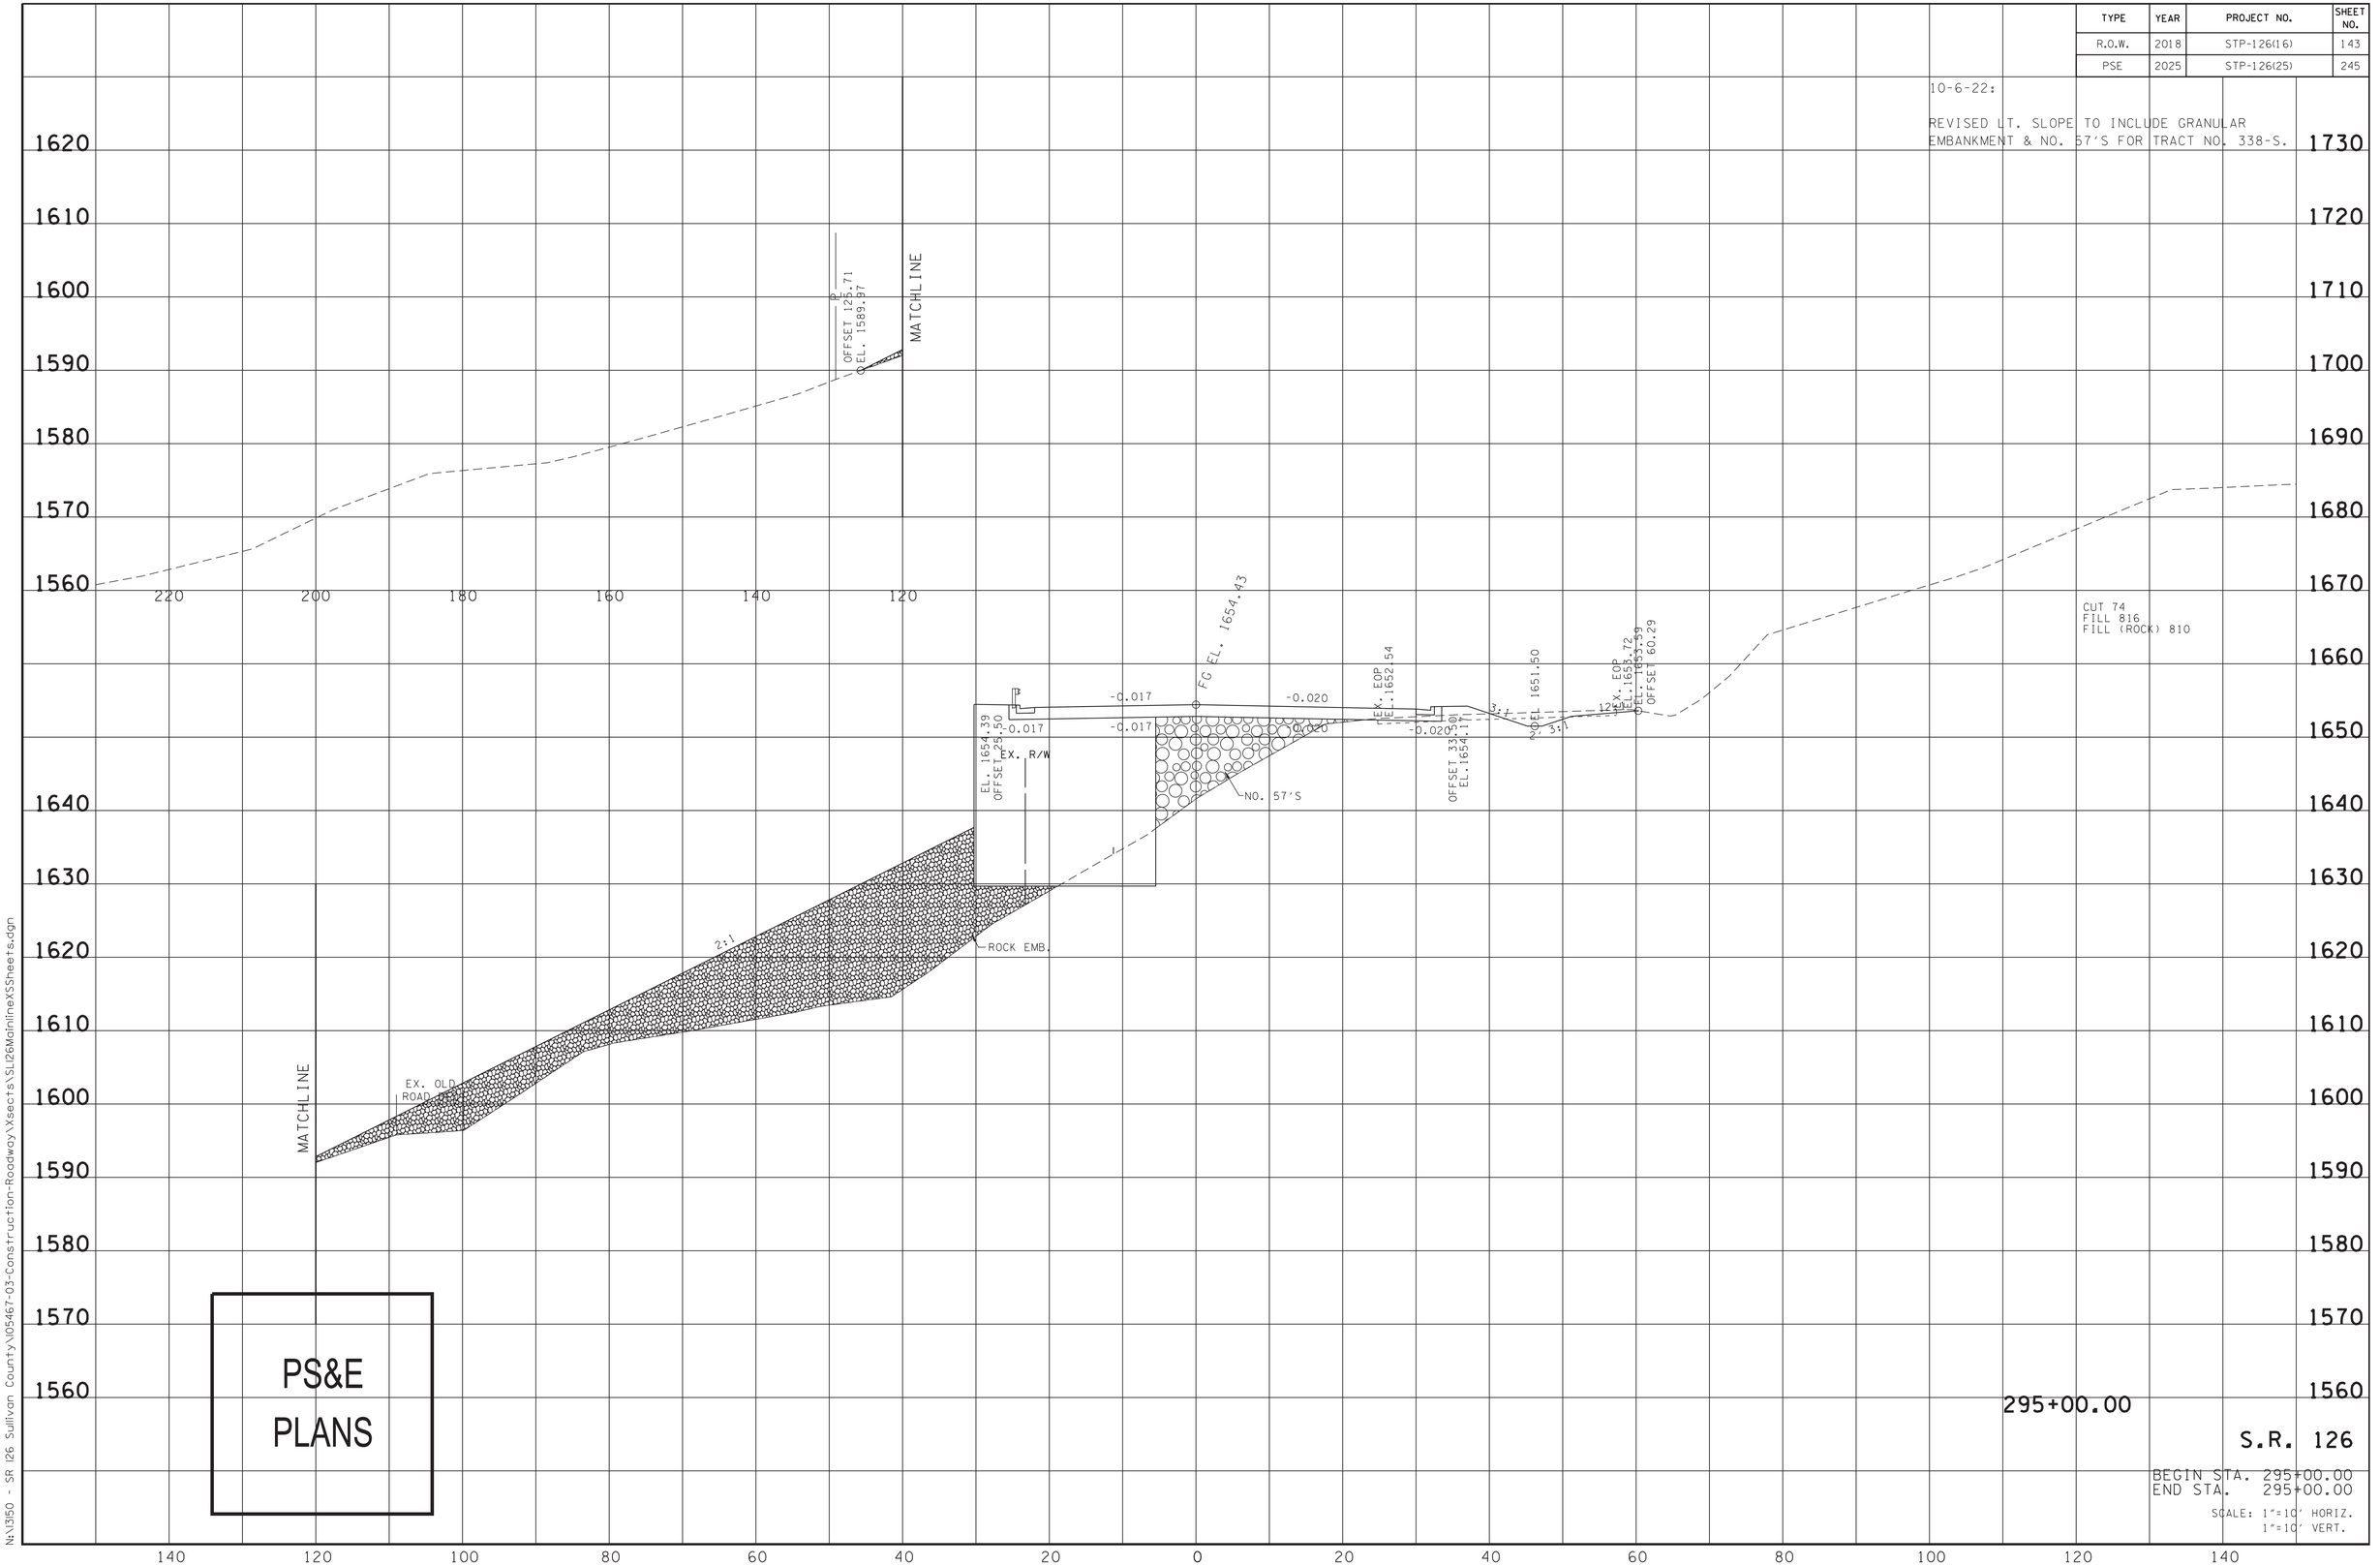
REVISED LT. SLOPE TO INCLUDE GRANULAR EMBANKMENT & NO. 57'S FOR TRACT NO. 338-S.

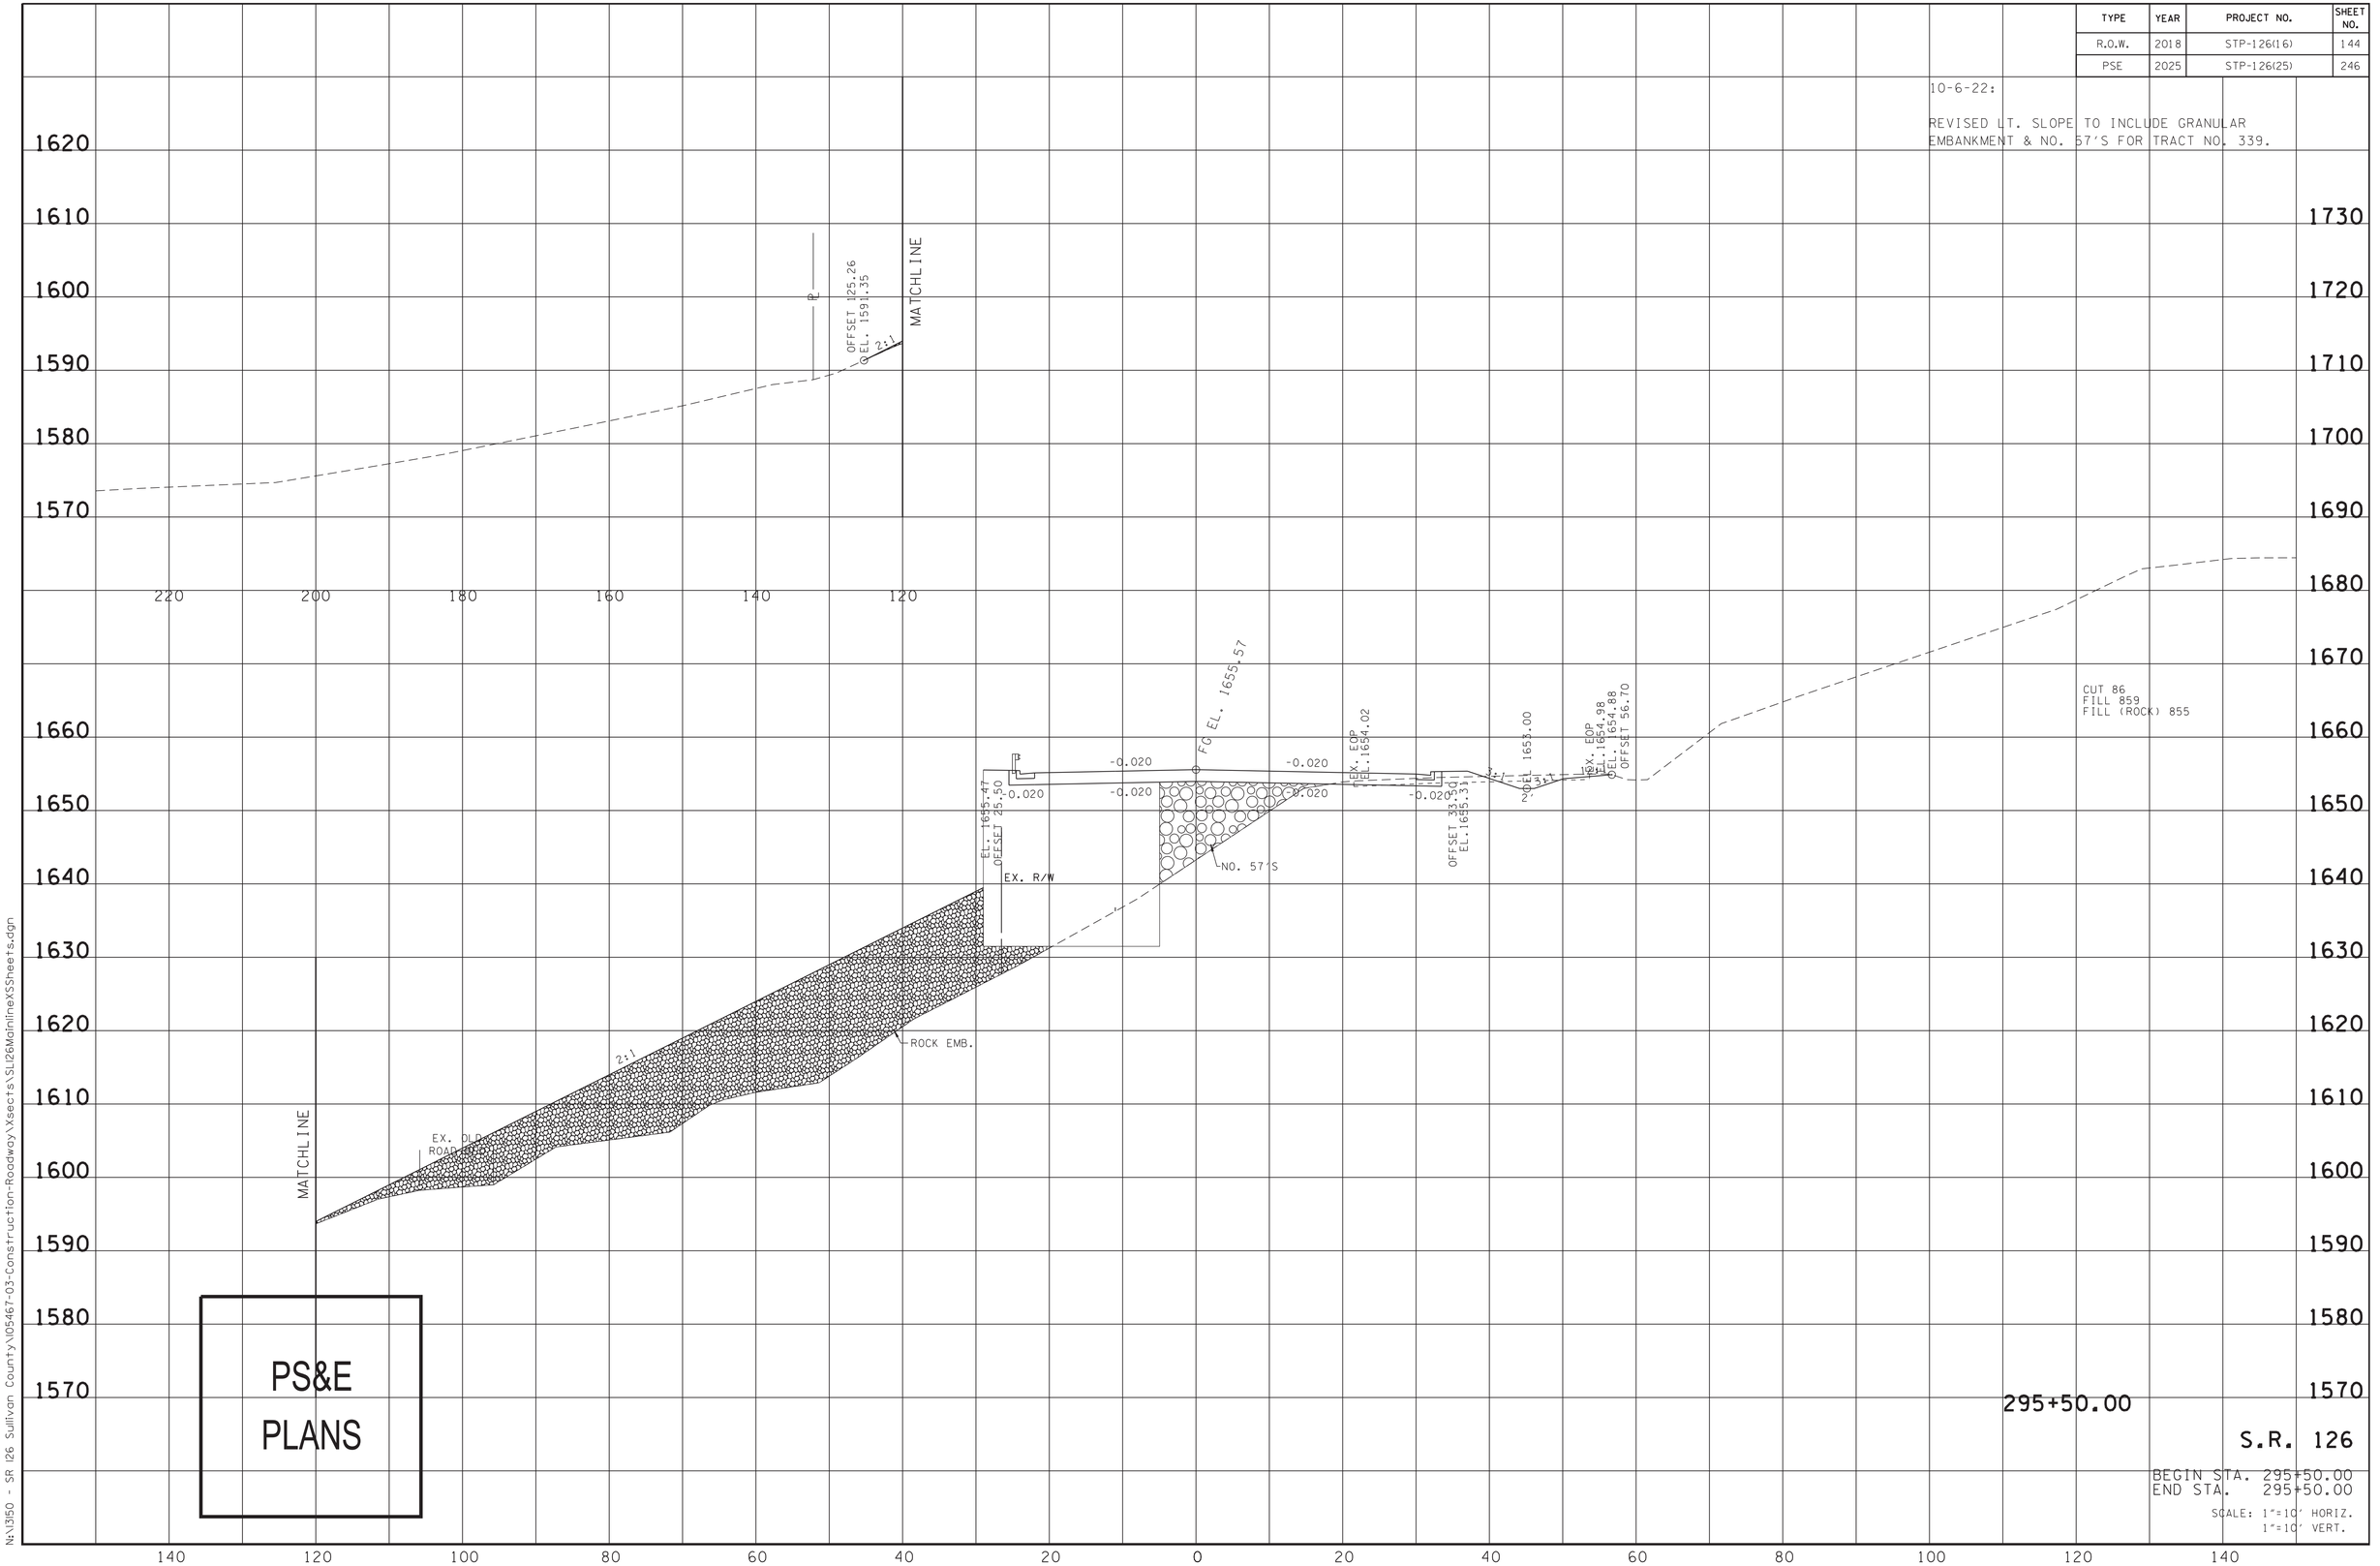
REVISED LT. SLOPE TO INCLUDE GRANULAR EMBANKMENT & NO. 57'S FOR TRACT NO. 339.

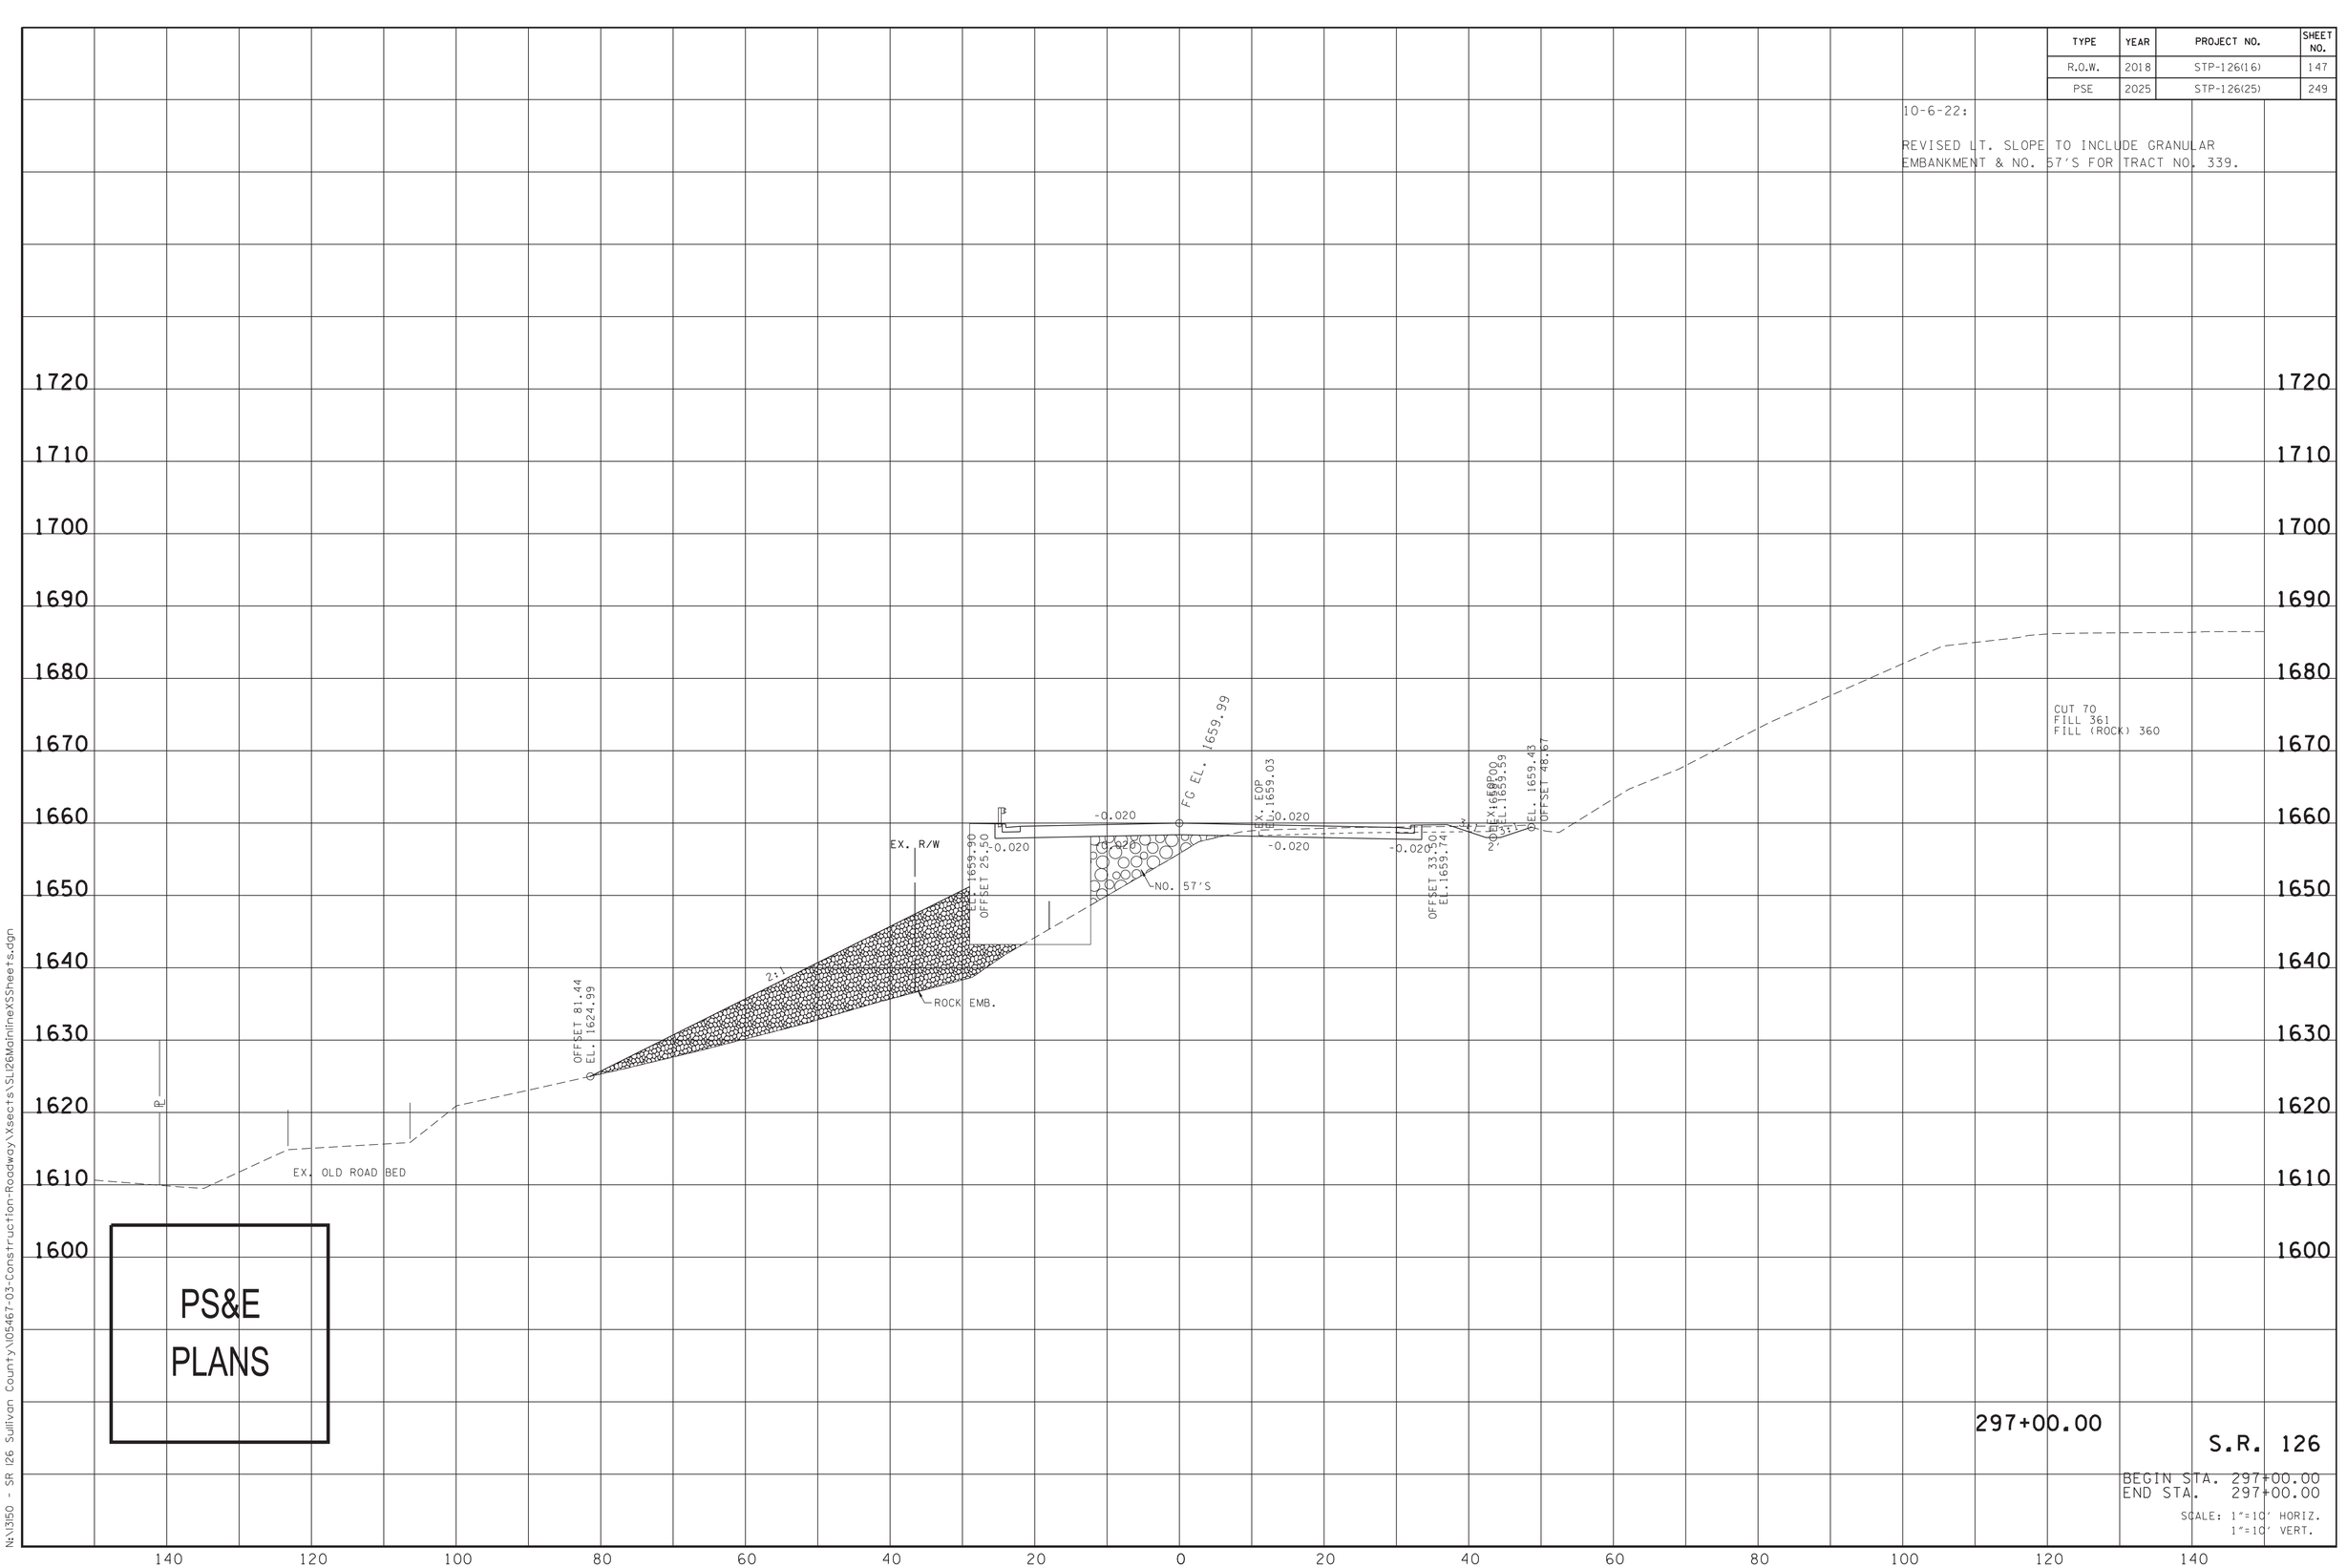
REVISED LT. SLOPE TO INCLUDE GRANULAR EMBANKMENT & NO. 57'S FOR TRACT NO. 339.
